INTEGRA UNDERGROUND

4 July 2016

PA 08_0101 and PA 08_0102 – Modifications to Integra Underground and Integra Open Cut Coal Projects

I refer to our telephone conversations and your emails of 10 and 31 March, 12 April, 3 May and 20 June 2016, in which you requested additional information to inform the Department's assessment and determination of the above modifications. Each of these requests is addressed separately below.

Attachment B: Updated Project Boundary Figure (Figure 4 in EA)

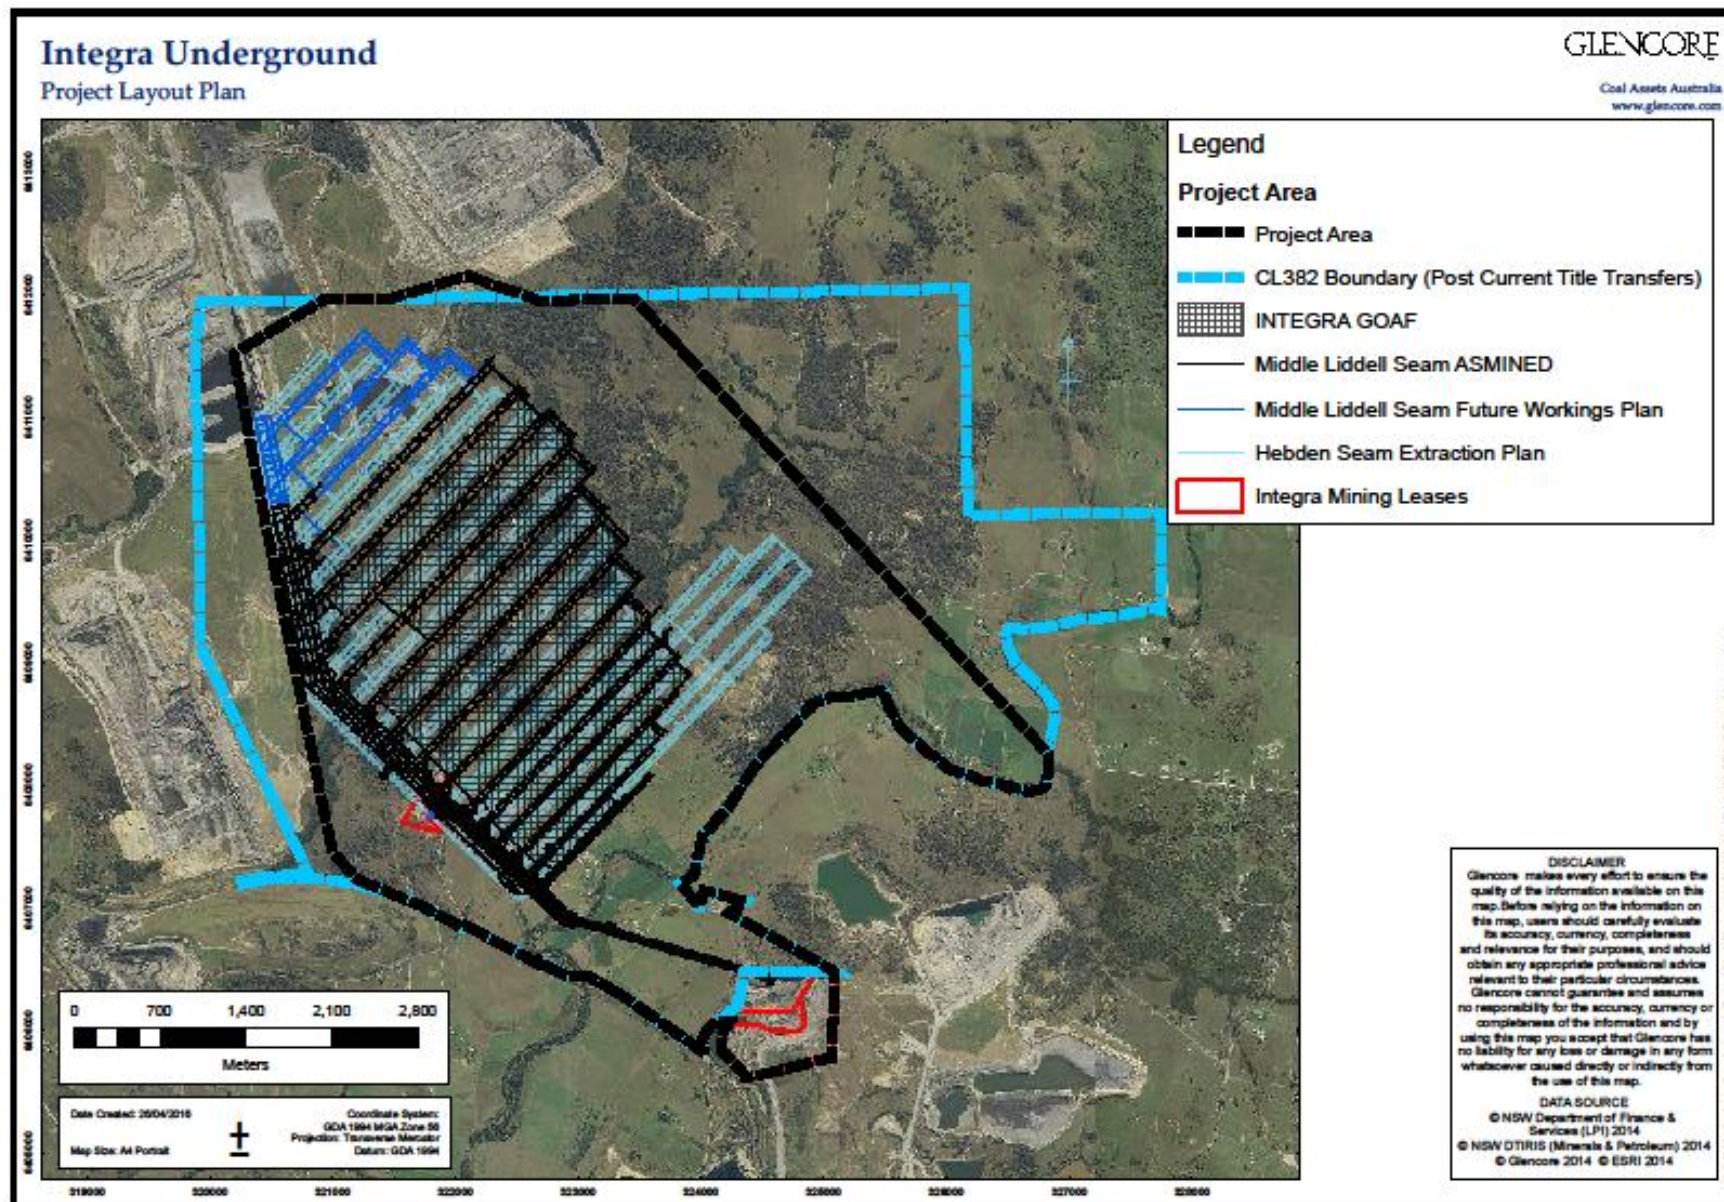
The proposed Underground Project Area in Figure 4 of the EA is larger than the currently approved boundary and appears to follow the tenement boundary.

- i. Could you please confirm that this figure is incorrect (and provide a correct figure)?*

Figure 4 in the EA is incorrect and we propose that it is replaced with the figure presented in **Attachment B**. A revised Schedule of Lands for the Underground Project is also provided in **Attachment B**.

- *Appendix 3 Project Areas*
 - PA 08_0101 (Underground) – Refer to figure in **Attachment B**
 - PA 08_0102 (Open Cut) – Refer to Figure 5 in Environmental Assessment

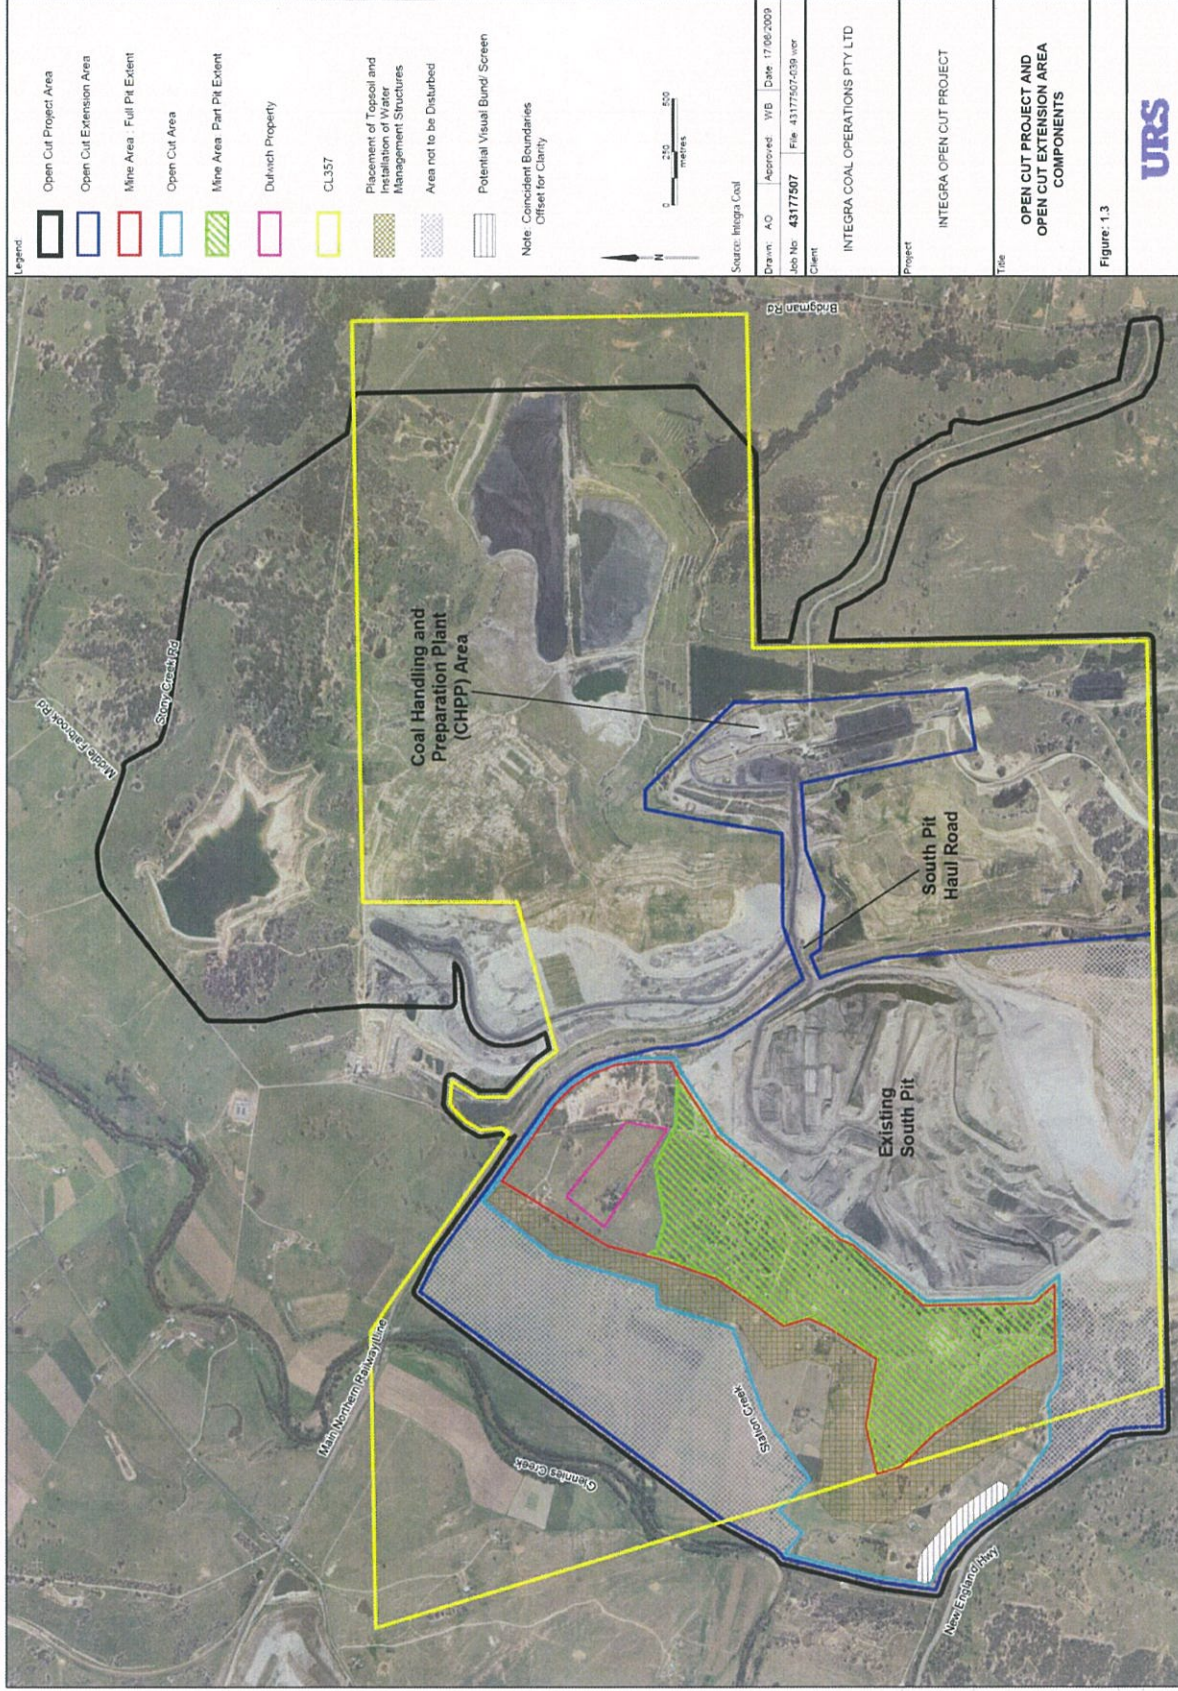
Please confirm the intention for all/some underground coal to be transported to and processed at the OC surface facilities for the period 2022 to 2035. Where the intention is to use the OC CHPP and TLO during the term of the UG PA, the Department would consider a request to extend the lapse date of the OC PA to align with that of the UG PA. This request would be considered within the current modification application assessment and would be dependent on the submission of appropriate information.

Due to the above there will still be considerable coal resources within the current Open Cut consent Mine Area at the completion of the current consent lapse date (22 December 2022). Attached is Figure 1.3, Integra Complex Consent, remaining in the Mine area Part Pit Extent is 25.1 ROM MT and within the Mine Area Full Pit Extent is 36.4 ROM MT. At the current projected production levels only approximately 50 percent of the resource in the Part Pit Extent will be completed by 2022.

Figure E1: Open Cut Project Layout

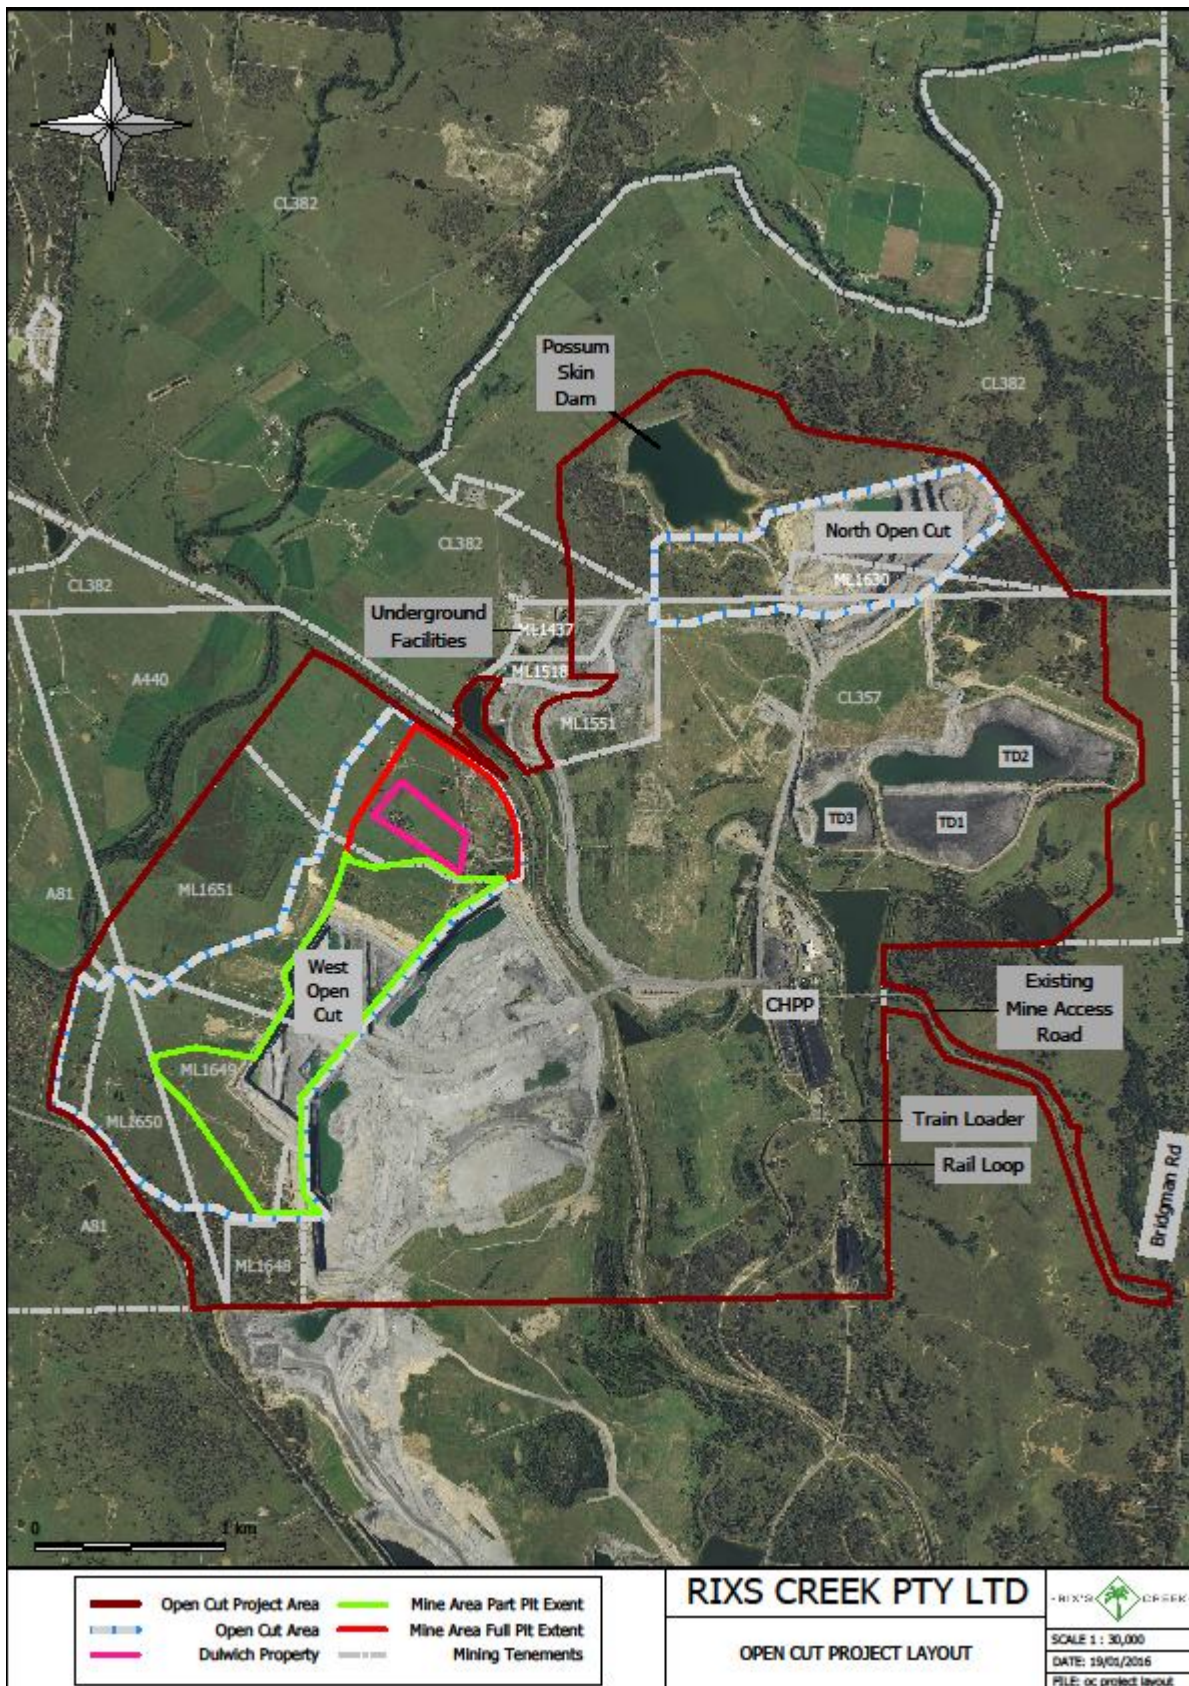
Please also consider which figures in the current consolidated Project Approval Appendices require updating with respect to the separation of the project approval boundaries and accommodation of TD2.

- *Appendix 4 Project Layout Plans*
 - PA 08_0101 (Underground) – The Project Area figure in **Attachment B** also indicates the Project Layout
 - PA 08_0102 (Open Cut) – Refer to **Figure E1** in **Attachment E**
 -
